RE: Homeland Towers application at
23 Dartantra Drive
ZBA Appeal No.: 3569

I have been asked by residents of the Town of East Fishkill to review the Visual Resource Evaluation for the proposed 150' telecommunications tower proposed for 23 Dartantra Drive. This review focuses only on the quality and completeness of the materials found in the Visual Resource Evaluation produced by IVI Telecom Services for Homeland Towers, dated January 30, 2012.

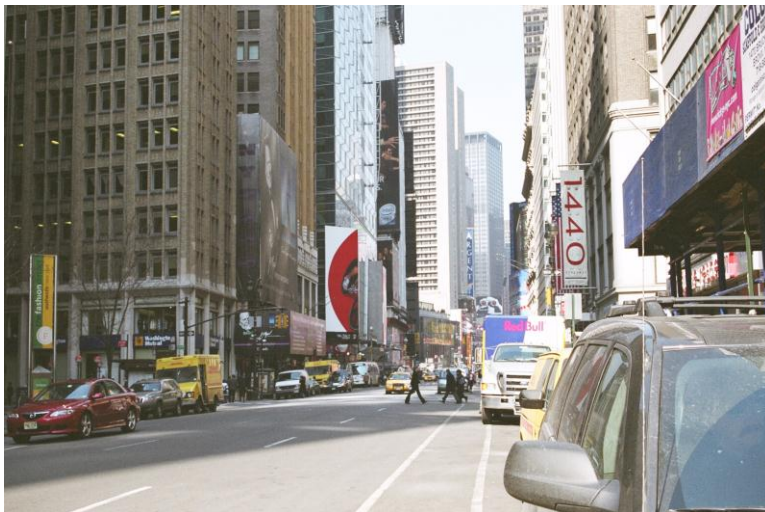
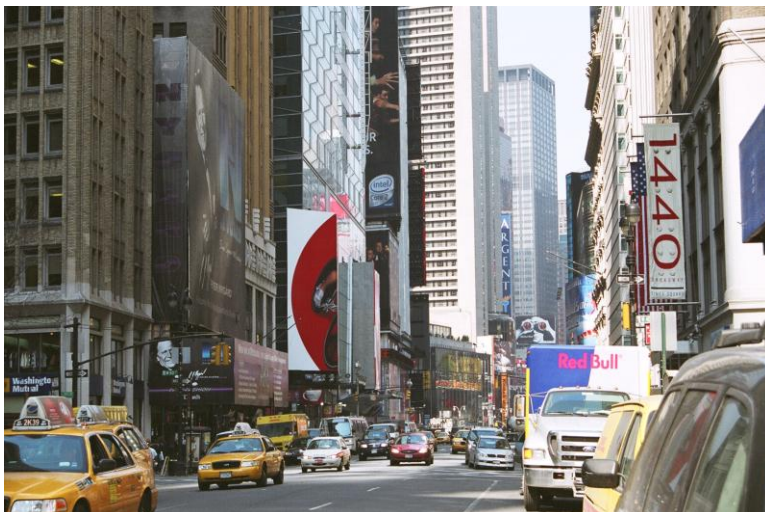
your own eyes. You will notice that everything seems relatively smaller in the photographs than they do in person. To illustrate this point, the following series of photographs were taken from the same location using different lenses.

Wide Angle (28mm)

Objects appear smaller and further away than they would to the human eye.

This lens is very close to what the applicant used.

Normal (50mm)

Closely approximates the relative distances as seen by the human eye.

The applicant should have used this lens.

Telephoto (80mm)

Objects appear closer and larger than they would to the human eye.

Sometimes used in visual assessments to simulate the acuity of the human eye in longer range shots.
